Supplements and specifications to Annex 1, Appendix 2, paragraph 21 of ATP

ATP HANDBOOK

Supplements to Annex 1, Appendix 2, paragraph 21 of the ATP Handbook

Transmitted by the Government of the Russian Federation

Fig. 1

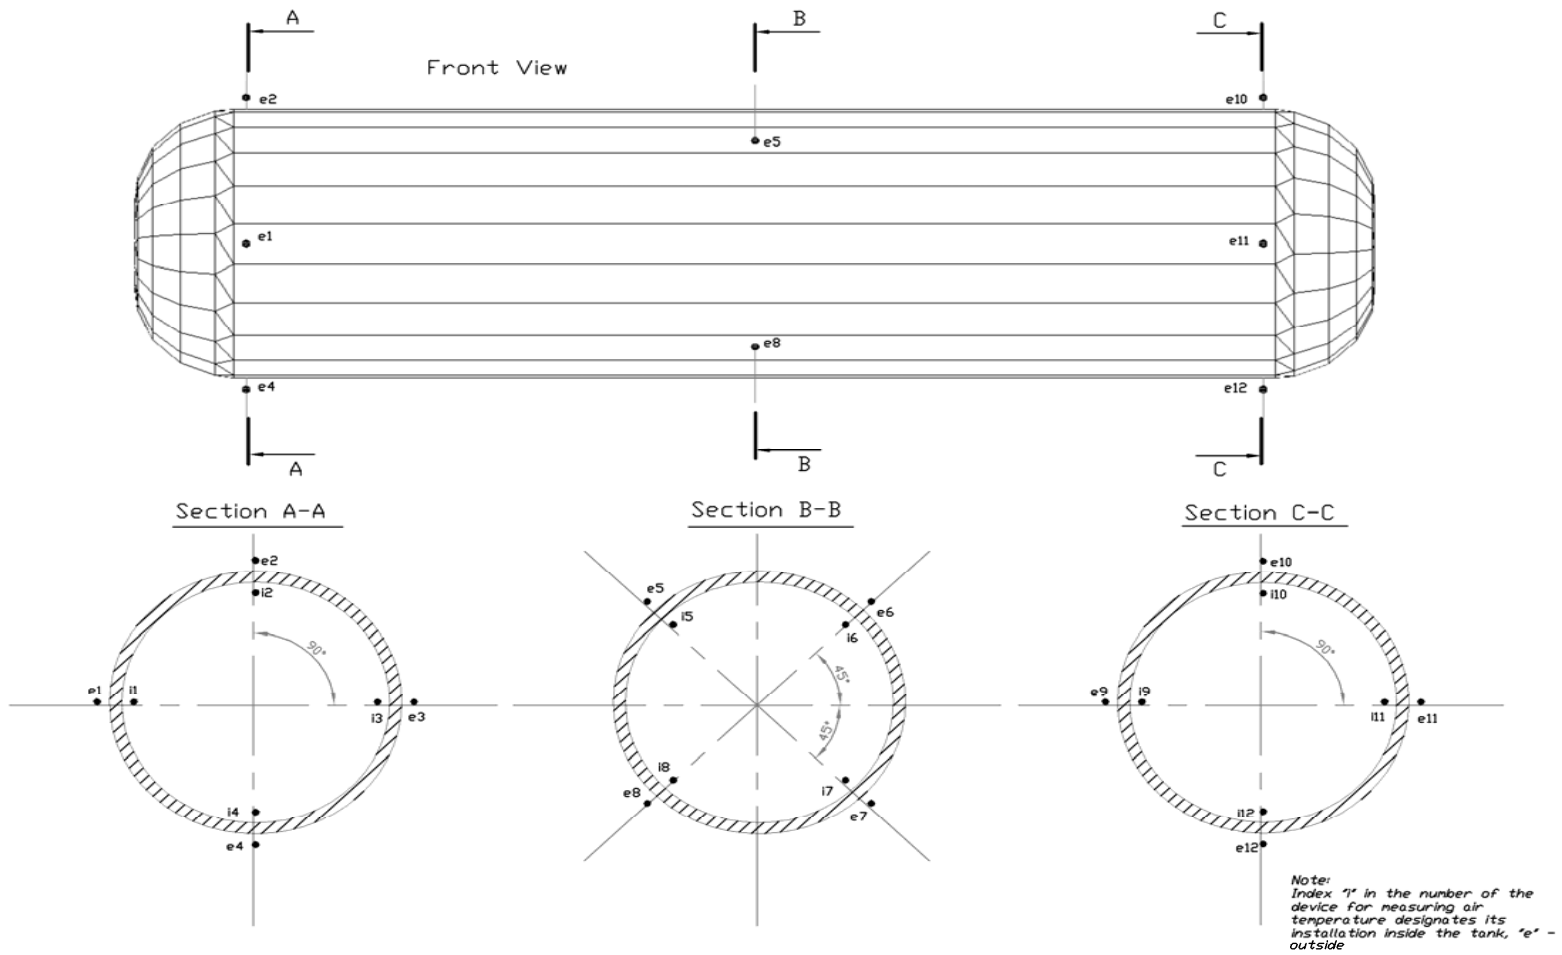
Comment to the current version of subparagraph (a) of Annex 1, Appendix 2, paragraph 21 of ATP:

"The layout of the placement of air temperature measurement devices inside and outside tanks with one compartment is shown in figure 1."

Fig. 2

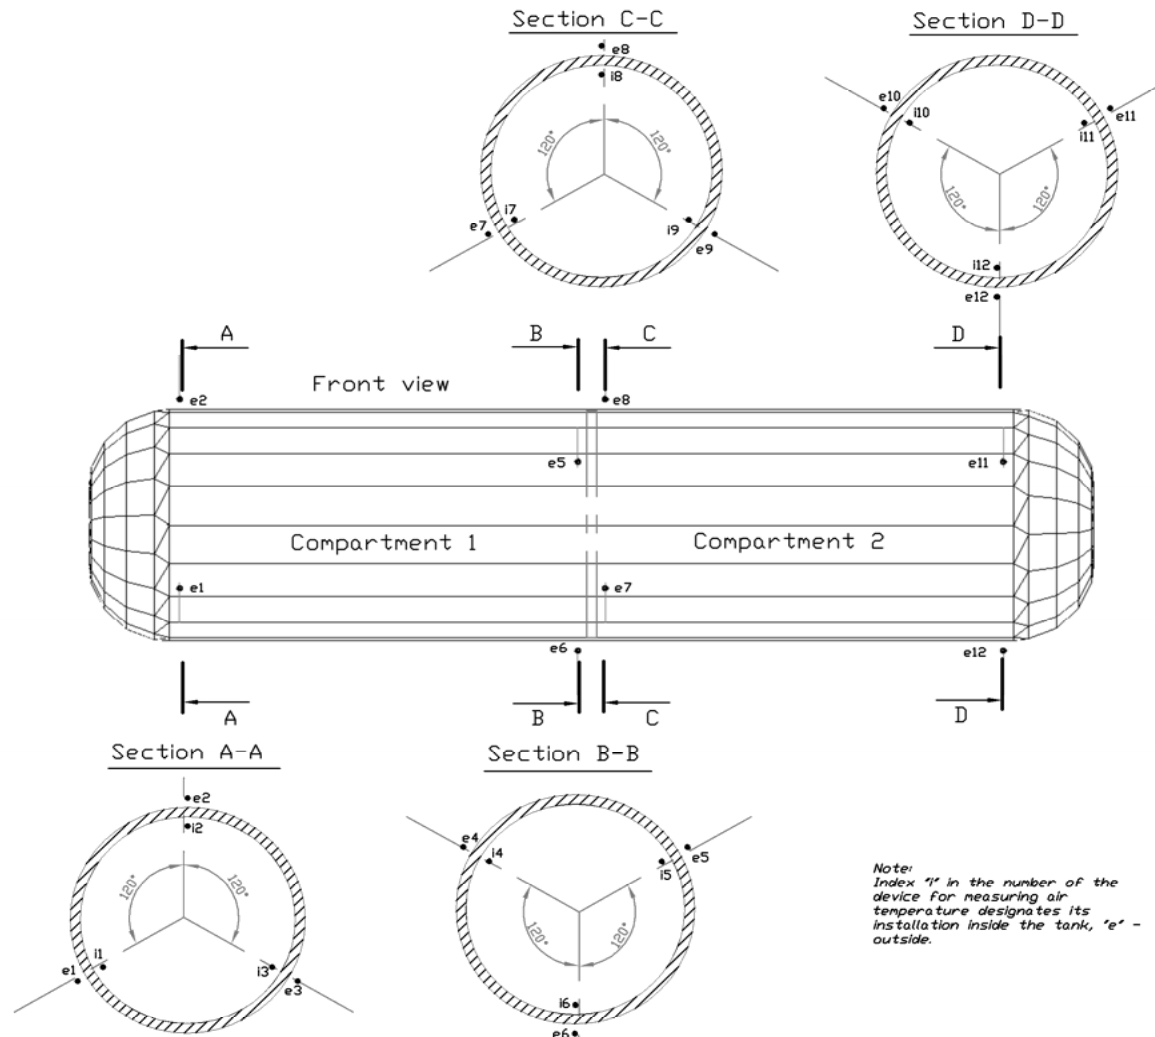
10. Supplement Annex 1, Appendix 2, paragraph 21 of ATP with a new subparagraph (b) as follows:

(b) *If the tank has two compartments, the measurements shall be made at least at the following points:*

- *Near the bottom of the first compartment and near the common partition in the second compartment – at the extremities of three radiuses forming 120° angles, one of the radiuses being directed vertically upwards;*
- *Near the bottom of the second compartment and near the common partition in the first compartment – at the extremities of three radiuses forming 120° angles, one of the radiuses being directed vertically downwards.*

Comment to the new subparagraph (b) of Annex 1, Appendix 2, paragraph 21 of ATP:

"The layout of the placement of air temperature measurement devices inside and outside tanks with two compartments is shown in figure 2."

Fig. 3

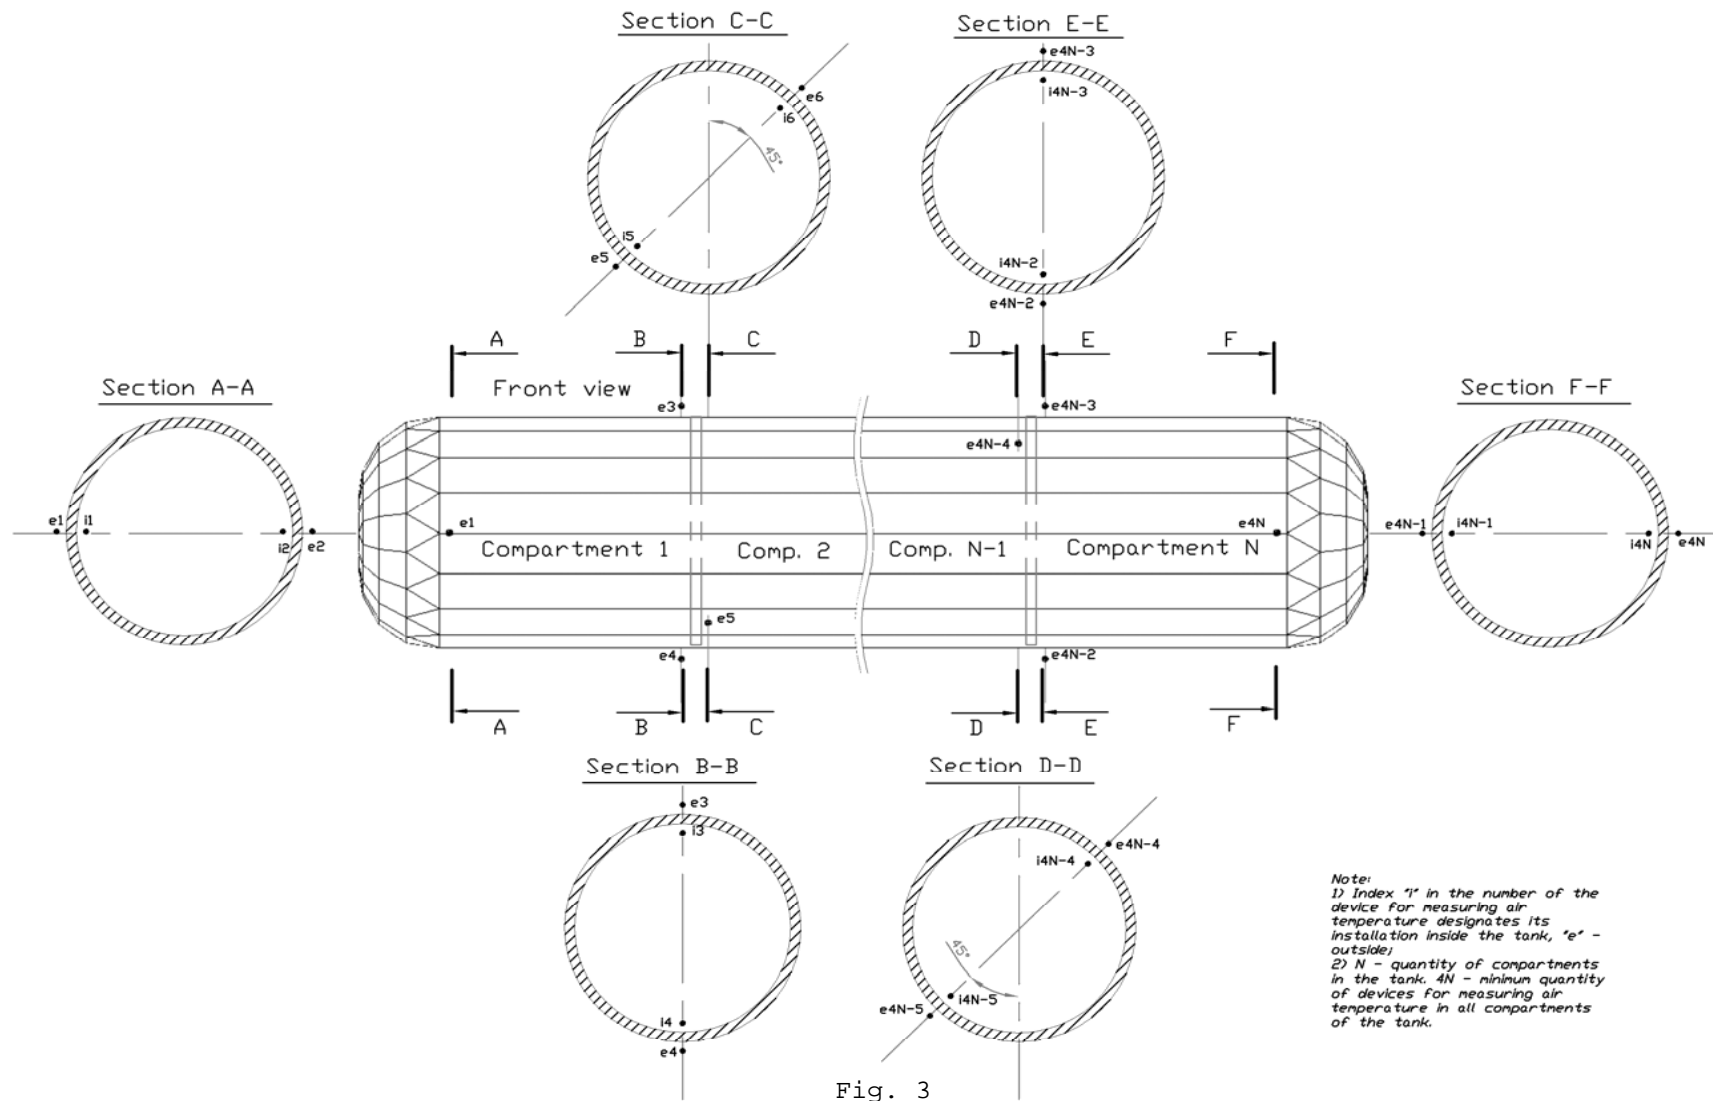
9. Amend the first indent of subparagraph (b) of Annex 1, Appendix 2, paragraph 21 of ATP as given below and change the notation from (b) to (c):

(c) *If the tank has three and more compartments, the measurements shall be made at the following points: ... {further according to the text}.*

Comment to the new subparagraph (c) of Annex 1, Appendix 2, paragraph 21 of ATP:

"The layout of the placement of air temperature measurement devices inside and outside tanks with three and more compartments is shown in figure 3."
